FROM: Peter Johansson
 TO: NCITS T10
 DATE: February 28, 1998
 RE: More SBP-2 Revision 3 Comment Resolution

This memorandum addresses the letter ballot comments on SBP-2 Revision 3 not previously resolved by 98-109r0 and SBP-2 Revision 3a. Those two previously published documents concern themselves with editorial issues, only. The technical issues were reserved for separate discussion.

Figure 60 – Fetch agent state machine

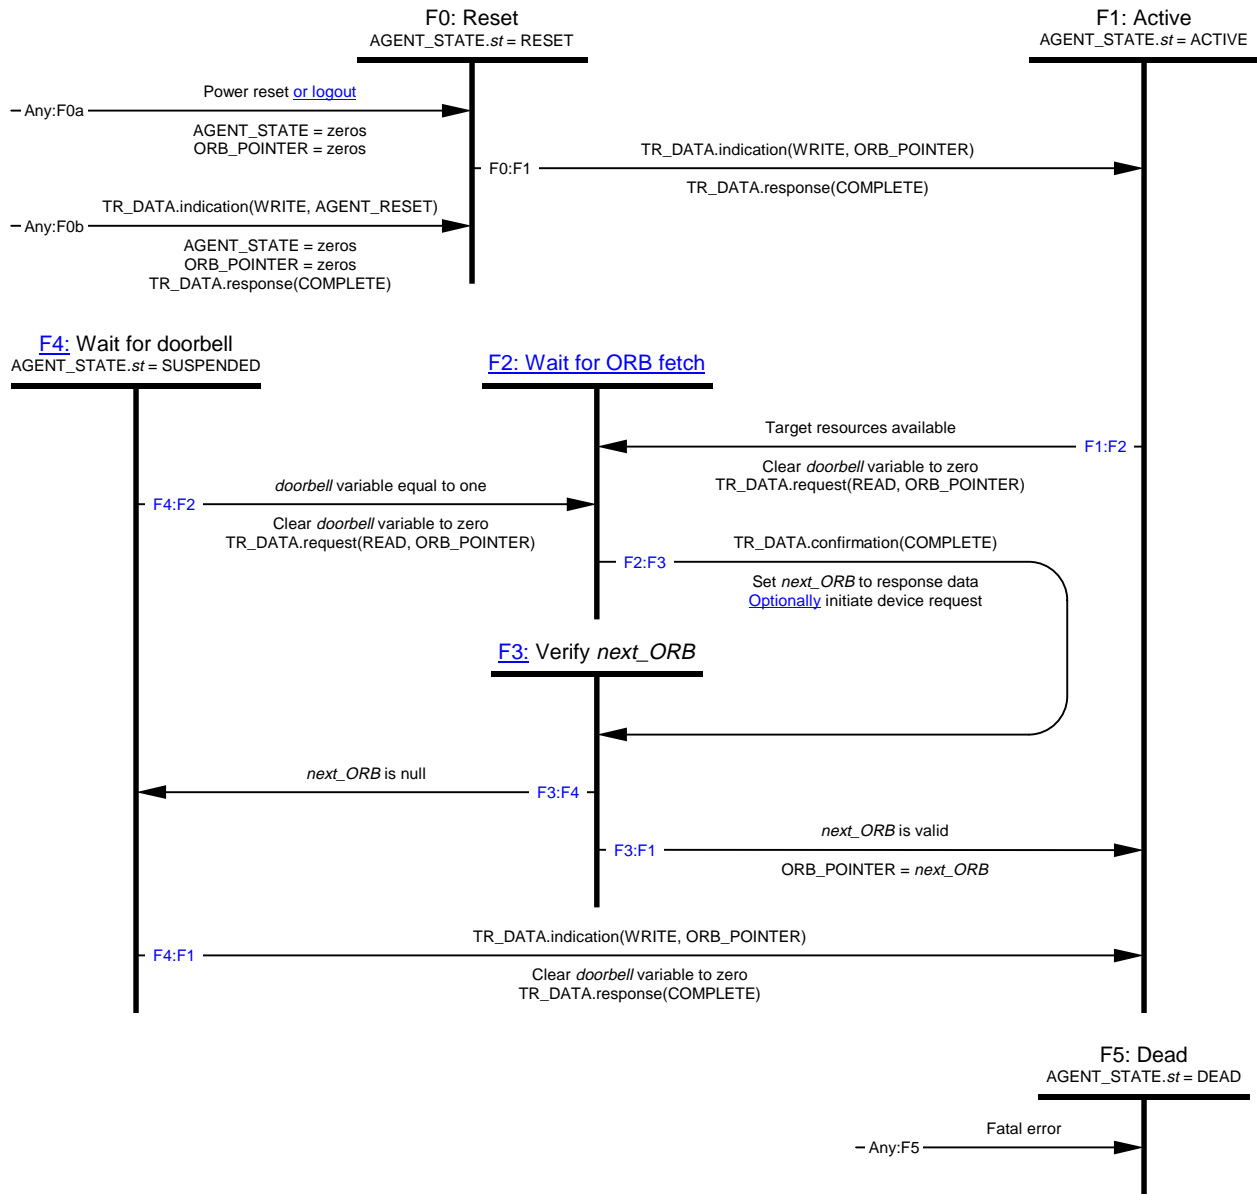
SF 121	Section 9.1.4, Figure 58: add the following changes... ...F0:F1, change the transition condition from "TR_DATA.indication(WRITE, ORB_POINTER)" to "Logged In and TR_DATA.indication(WRITE, ORB_POINTER)"	See 9.1.4 and a redrawn state diagram at the end of this document. The text that precedes Figure 60 makes it clear that <i>all</i> writes to the fetch agent CSR's require the initiator to be logged-in. There's no need to add this extra text to the diagram itself.
SF 122	Section 9.1.4, Text describing transition Any:F0b: Add the following sentence at the end: "If a read request for an ORB is outstanding, the subsequent response (if any) should be accepted but the content of the response should be discarded."	Added " Transaction label(s) for outstanding request subactions shall not be reused until either the corresponding response subaction completes or a split time-out expires; in the former case, the response data shall be discarded. "

Reference	Ballot comment	Proposed resolution
SF 126	Section 9.1.4, Text describing transition "F3:F2" to "F3:F1". Delete the phrase ", set the next_ORB variable to the value of the ORB_POINTER register", change "F2" to "F1" and delete the phrase ", from which state an immediate F2:F1 transition follows."	
SF 127	Section 9.1.4, Text describing transition F4:F2, delete the last sentence.	
SF 128	Section 9.1.4, Text describing transition Any:F5, the list of errors gives an indication that only errors associated with the fetching process cause this transition. Add two new bullets "- any device level error" and "- any transport error encountered during the transfer of data or status related to a command being processed that was fetched via this fetch agent."	It is not necessarily true that all “device level error” causes the fetch agent to halt nor is it necessarily true that all errors in the transfer of data for a particular command cause the fetch agent to halt.

SF 129	Section 9.1.4, Text describing transition F5:Dead, change "AGENT_STATE" to "DOORBELL". The AGENT_STATE register is read only.	Accepted with modifications; see 9.1.4 at the end of this document.
SF 131	Section 9.2, second paragraph, add a new sentence to the end of the paragraph "The target is also responsible for generating the proper system memory address appropriate for the transfer being performed."	There is no way the target can performed the required data transfer functions without generating appropriate system memory addresses. The proposed text doesn't add anything.
SF 132	Section 9.3, related to the last paragraph before the note. We have never included any text to define how to reclaim an ORB that returns a status with the <i>src</i> field equal to one. After this last block is updated with a new ORB pointer value and the doorbell is rung, when can the old ORB be discarded? One way is to monitor the ORB pointer and see if it has changed. This would require polling. Another is to wait until the ORB whose address was placed in the old ORB completes. This could be a long time if a linked list is appended and the device does out of order transactions. I don't have a fixed solution, but we need one.	It could be a very long time, regardless of the execution model! I've added " When src has a value of one, the system memory shall not be reused or deallocated until the target stores completion status for some subsequent ORB in the linked list. ". I've also strengthened the note as follows: "NOTE – For targets that support the ordered model of task execution, the return of completion status for an ORB implicitly indicates that all preceding ORB's in the linked list have completed successfully, are no longer part of the task set and that the initiator may reuse or deallocate their system memory. "

Transition F0:F1. An 8-byte block write of a valid *ORB_offset* to the ORB_POINTER register shall update the register and cause the fetch agent to transition to state F1. The target shall confirm the block write request with a response [subaction](#) of COMPLETE.

Transition F3:F1. If the *next_ORB* variable does not indicate a null pointer the fetch agent shall update the ORB_POINTER register with the value of *next_ORB*.

Transition F4:F1. If an indication of a write to the ORB_POINTER register is received, the fetch agent shall clear the *doorbell* variable to zero, ~~set the next_ORB variable to the value of the ORB_POINTER register~~ and then confirm the write transaction with a response [subaction](#) of COMPLETE. After the confirmation, the fetch agent shall transition to state F1, ~~from which state an immediate F3:F1 transition follows.~~
